Staff Report
City of Richmond, Virginia

Commission of Architectural Review

| 6. COA-115904-2022 | <p>Conceptual Review</p> <p>Meeting Date: 8/23/2022</p> |
| Address: 912 Tulip Street | |

Figure 4. Existing commercial building looking southwest from Tulip Street.

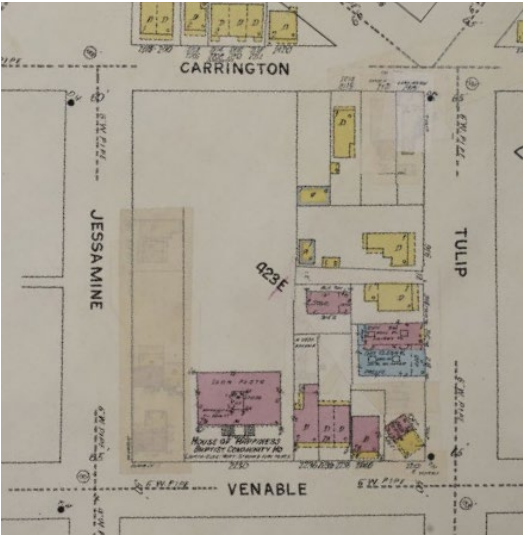
| | | Staff does not find the glass block window to be a character defining feature and feels that increasing the amount of transparency between the store and street creates a more successful pedestrian realm. <u>Staff recommends that the new store front windows on the existing commercial buildings match the configuration seen in the historic photograph as closely as possible.</u> |
